C0960-006
May 20, 2020

**Re: Site Review Permit & Conditional Use Permit for Parking Applications
Proposed Multi-Family Development, 105 Bartlett Street, Portsmouth, NH**

The enclosed revised plans and supplemental materials have been provided to address comments received from the Technical Advisory Committee (TAC) at their meeting held on May 5, 2020. Also enclosed is a Site Review Comment Response that includes responses to City staff comments.

City of Portsmouth TAC, May 05, 2020:			
	TAC Comment	Applicant Response	Sheet
TAC Comments from 5/4 Correspondence:			
1	Plans list proposed building height 54 story and 50' for buildings B and C, this appears to be a typo as the building is proposed to be 5 stories using the overlay district zoning. Please correct.	The site data table has been revised to a 4 story and 50' for buildings B and C.	C-102
2	A detailed building height plan should be submitted showing the average grade plane and heights along the perimeter of the building.	An average grade plane exhibit has been added to the submission package.	Grade Plane Exhibit
3	An application for a lot line adjustment is also being submitted, please clarify on plan set if the lot dimens

FIRE TRUCK TURN AROUND

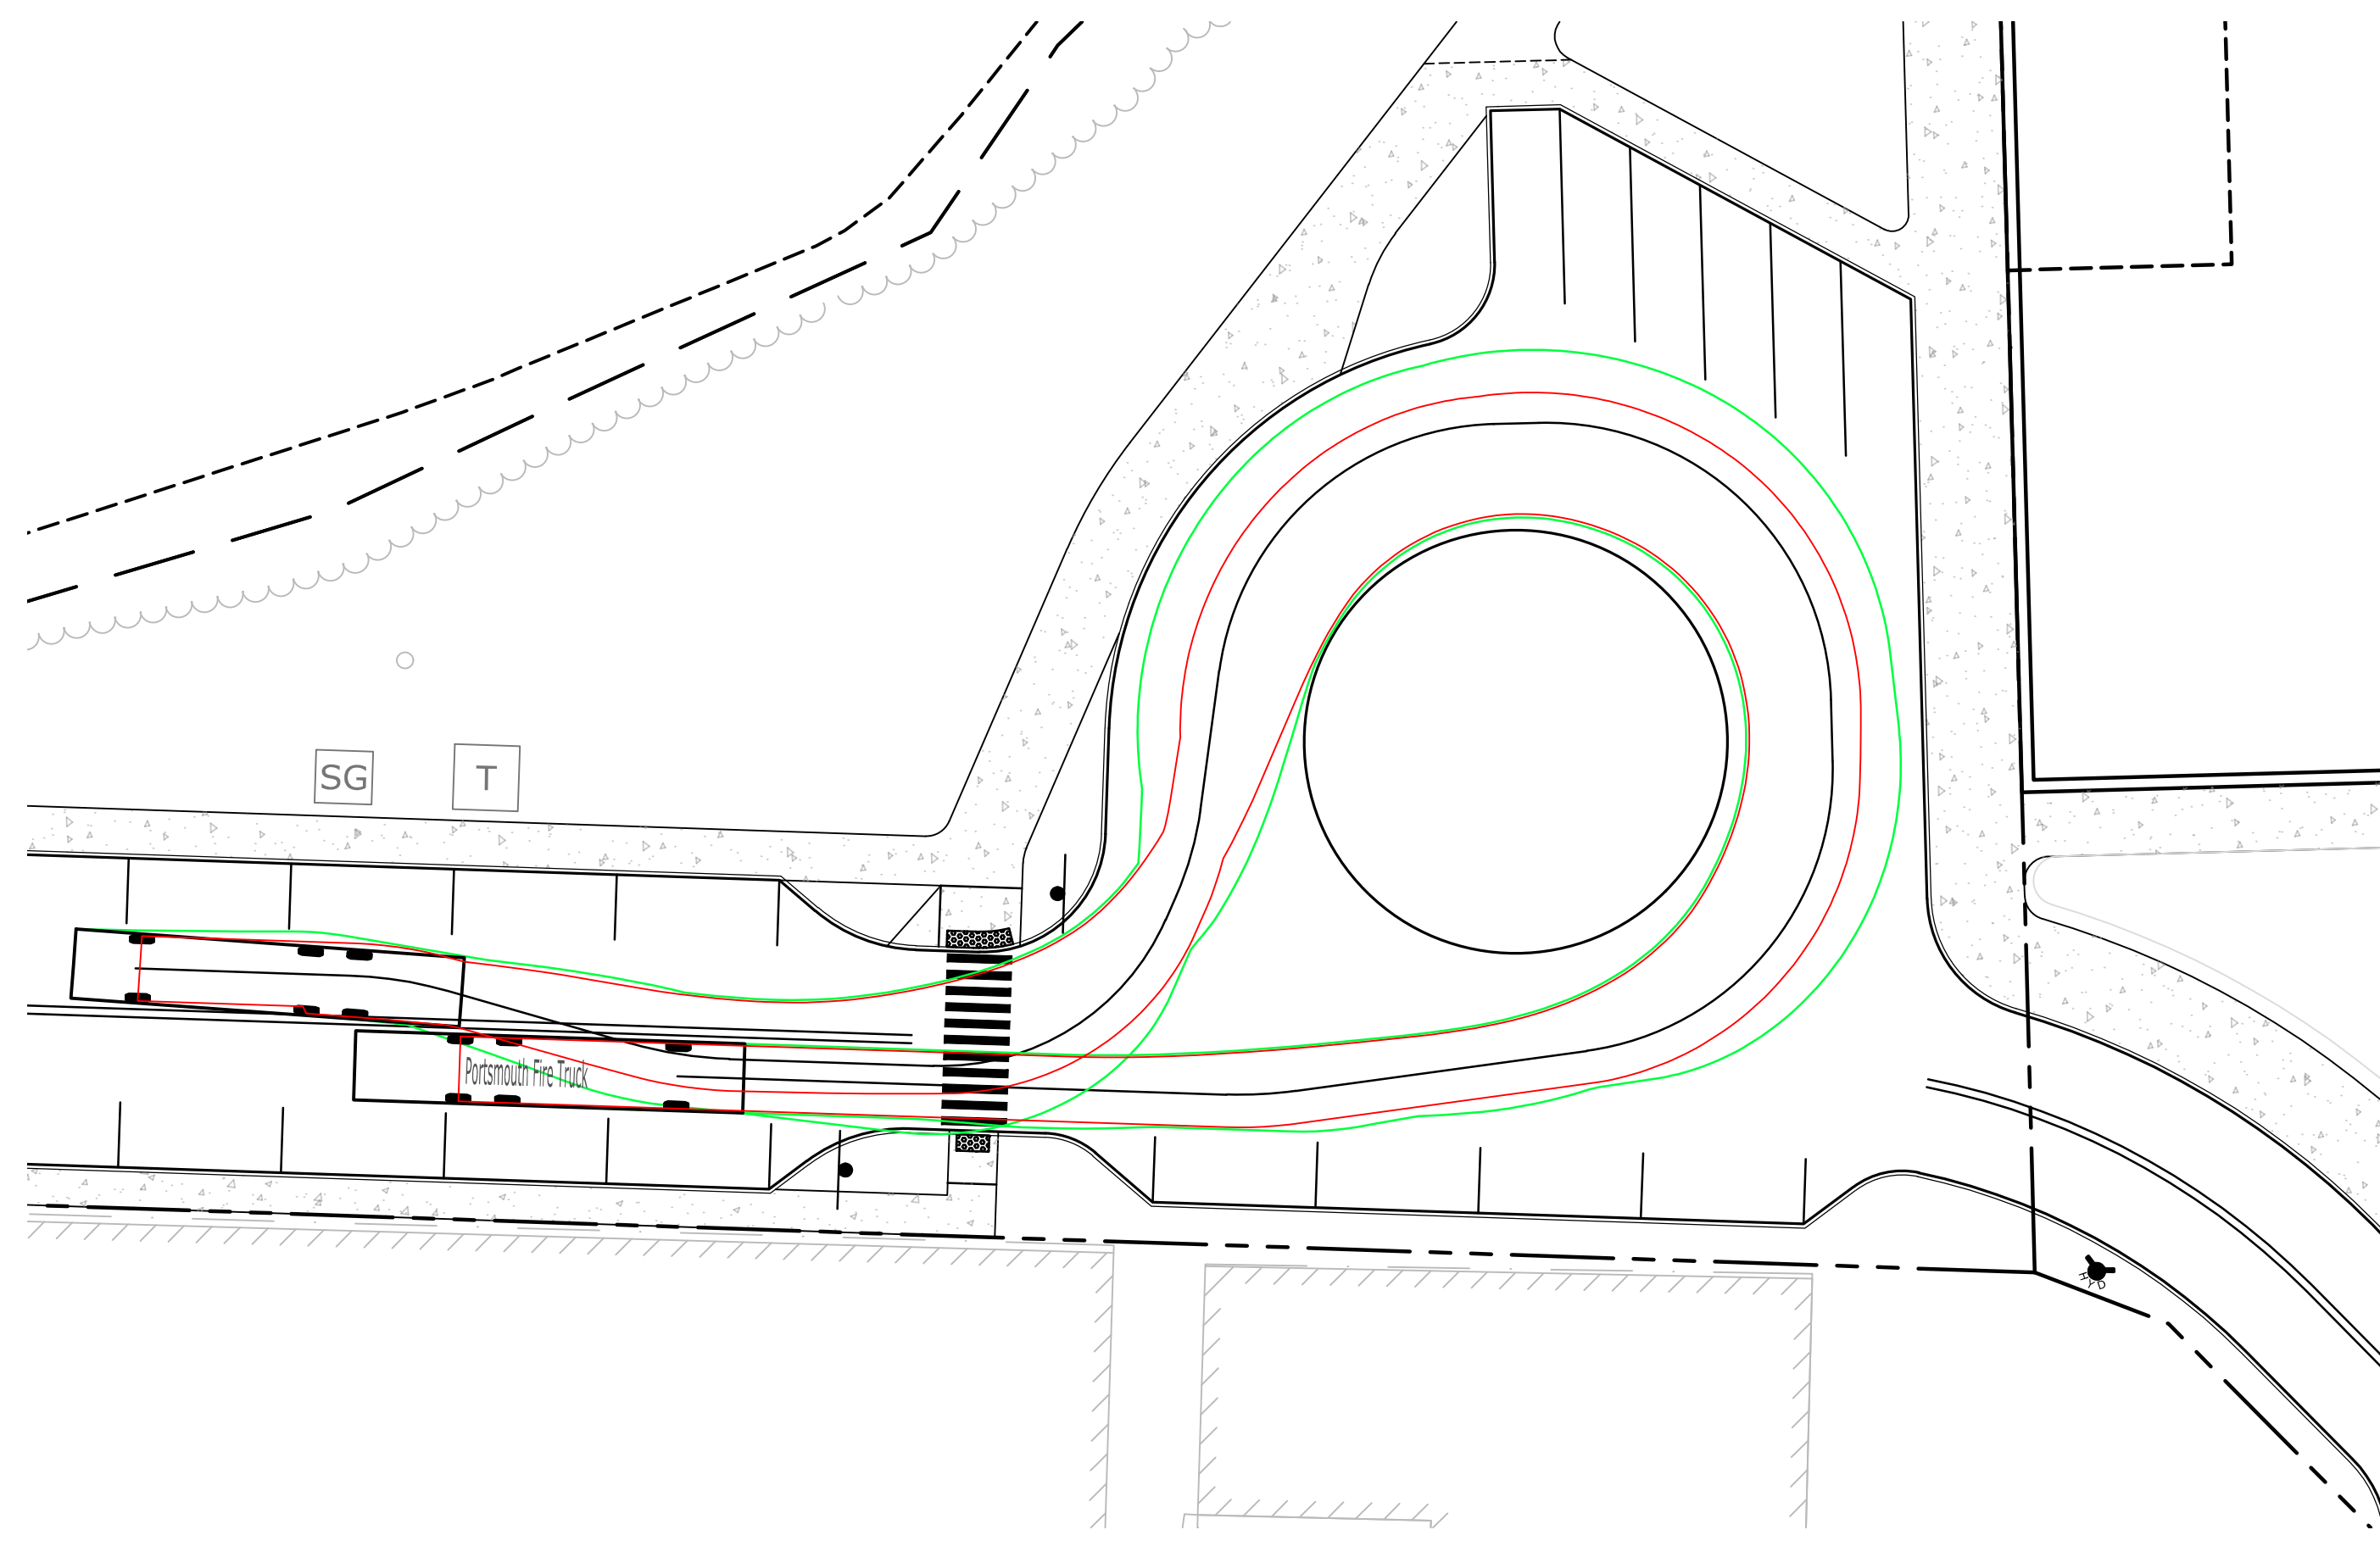
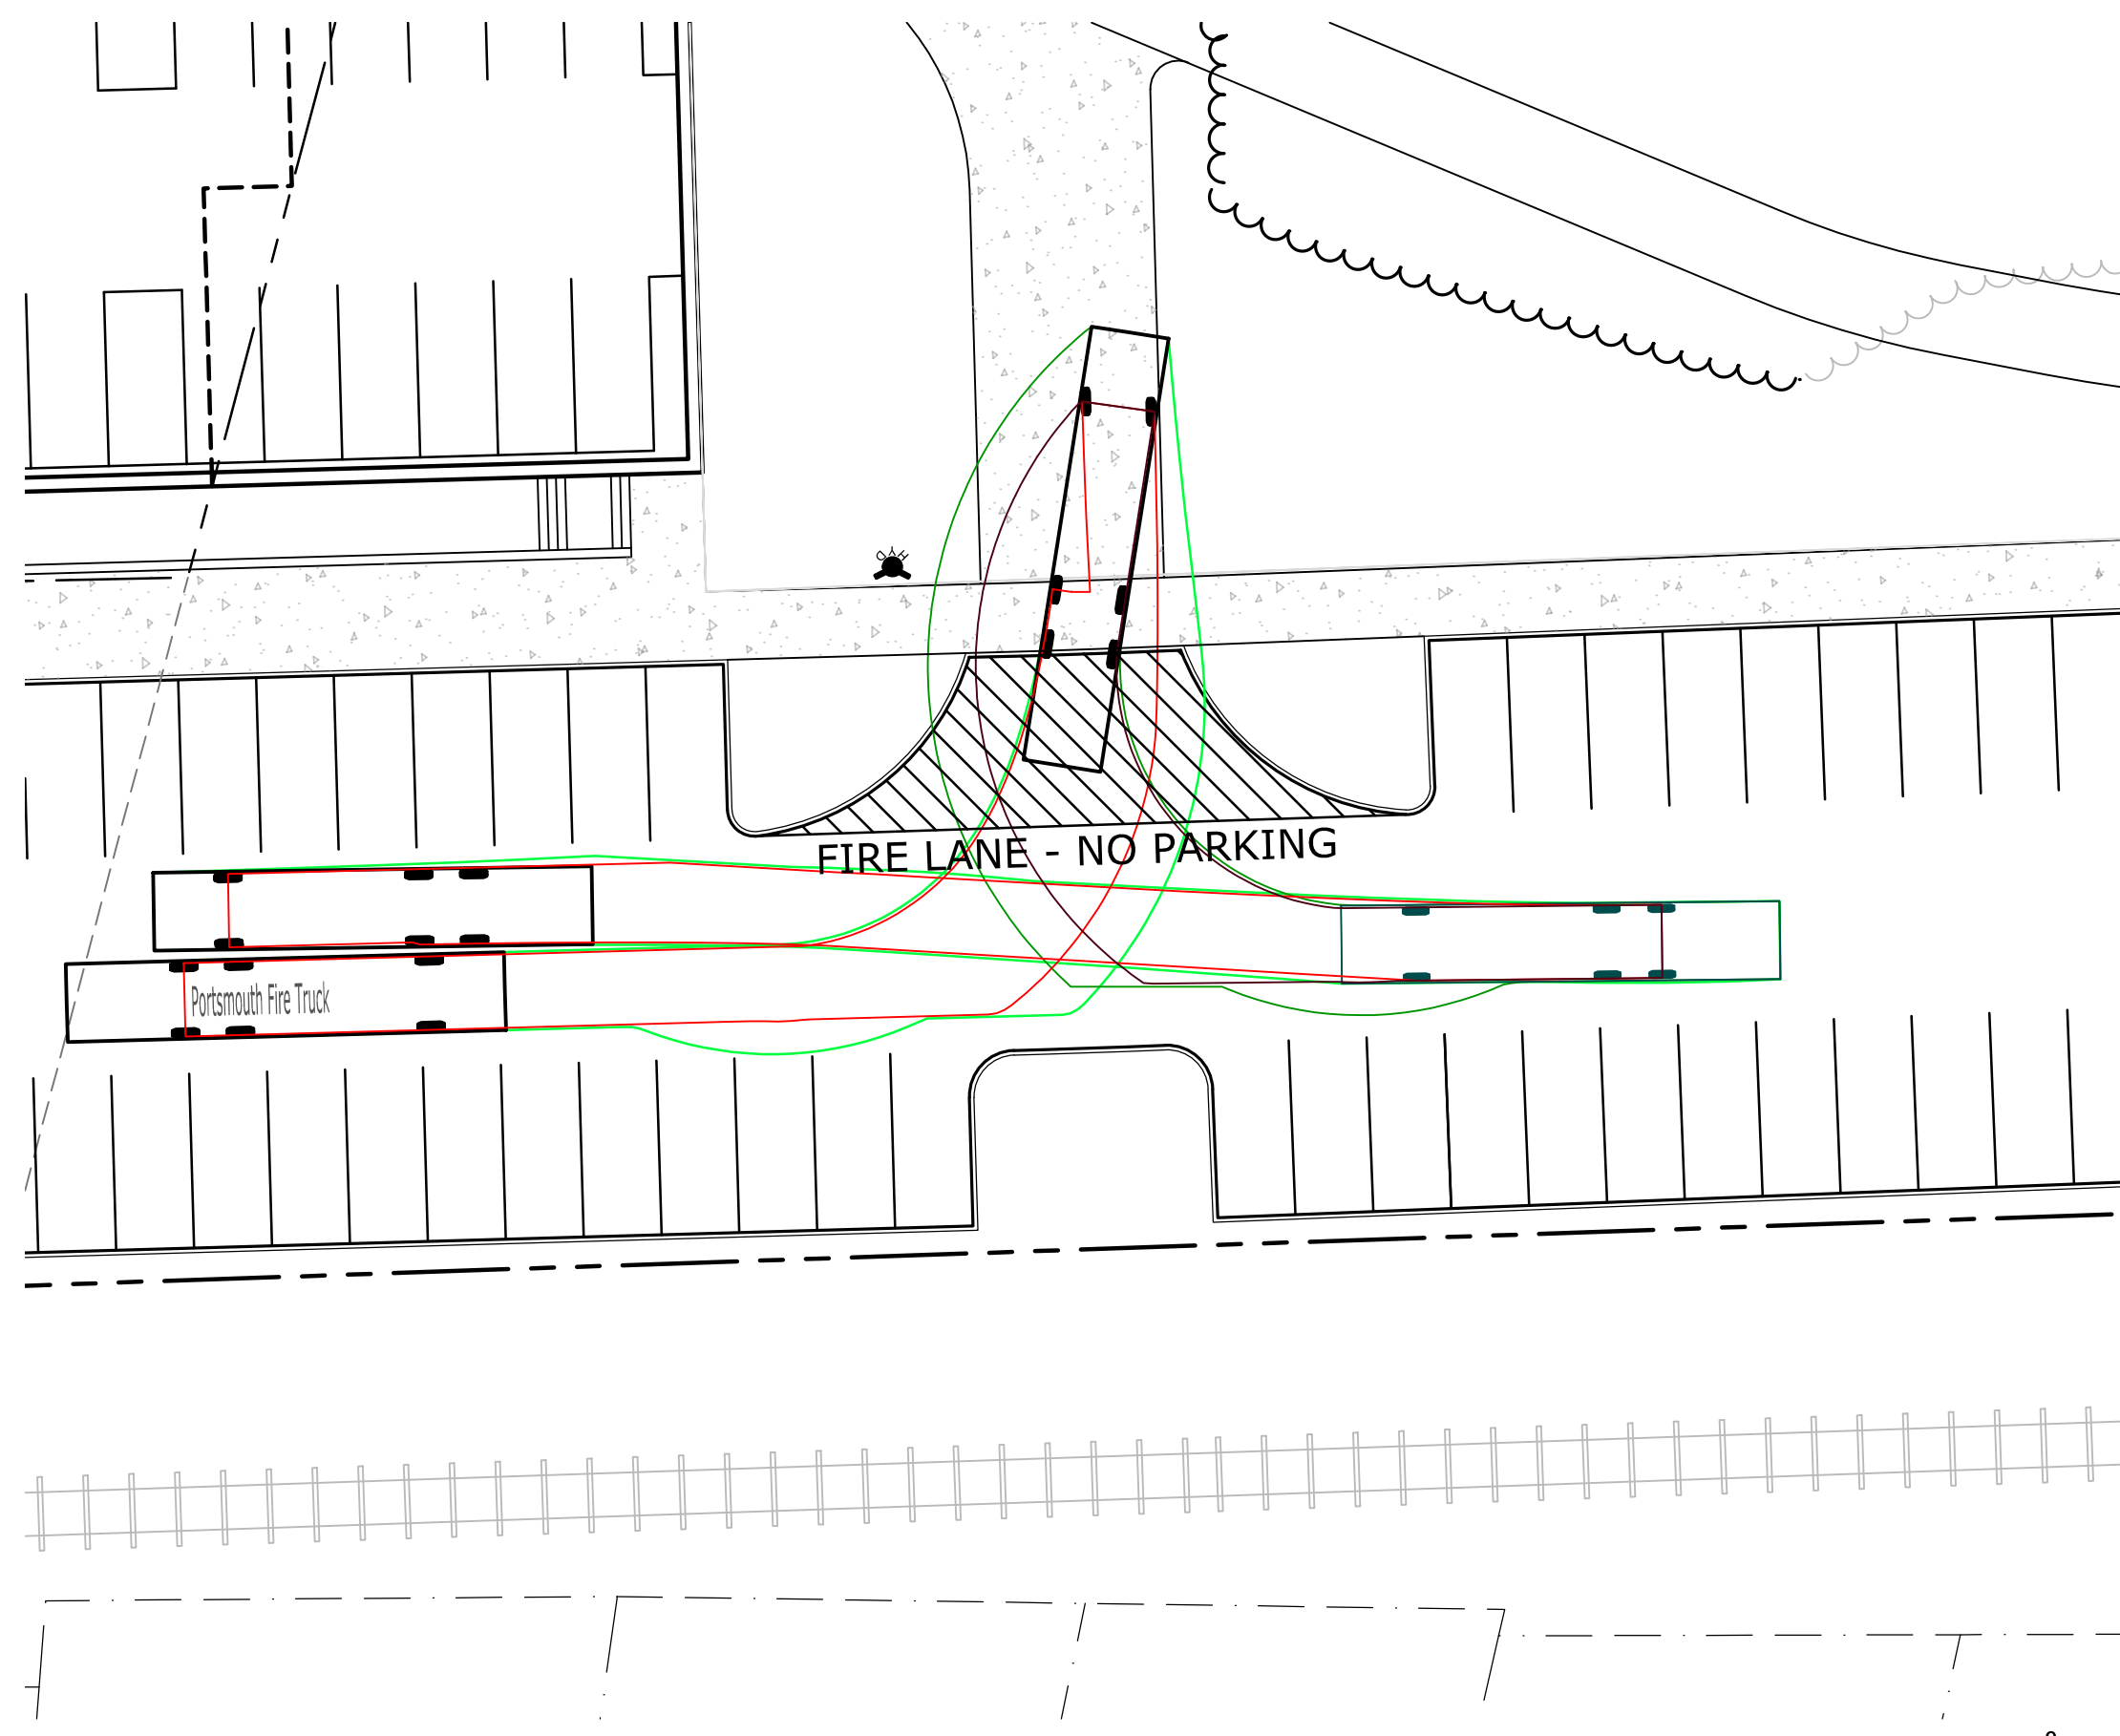
Additional Comments from 5/5 TAC Meeting:			
34	Fire department is concerned with access to Building B.	A fire truck turnaround has been added to the northeast of Building A. The turnaround has been extended to the future multi-use path to allow for emergency vehicle access in the rear of the buildings. As shown on the turning templates, a fire truck has the ability to access rear of Building B if necessary.	C-102 & C-102.2, Truck Turning Exhibit
35	Buildings A & B may be considered as one building for fire code purposes due to the connected basement.	All three (3) buildings will be designed to meet applicable fire codes. Per zoning, Buildings A & B are measured as two (2) building footprints based on the average grade plane elevation shown in the enclosed Grade Plane Exhibit.	Grade Plane Exhibit
36	Applicant shall consider the potential to use the multi use path as fire access in rear of building.	A fire truck turnaround has been added to the northeast of Building A. The turnaround has been extended to the future multi-use path to allow for emergency vehicle access in the rear of the buildings. As shown on the turning templates, a fire truck has the ability to access rear of Building B if necessary.	C-102 & C-102.2, Truck Turning Exhibit

43	Show fire truck template through the site, overhang hits cars at cul-de-sac exit.	Fire truck turning template has been updated showing movement through the site.	Truck Turning Exhibit
44	Check previously approved road in to see if variances were required for parking in front of the Ricci design center.	A proposed easement is shown for the parking that extends into the proposed road lot.	C-301.1
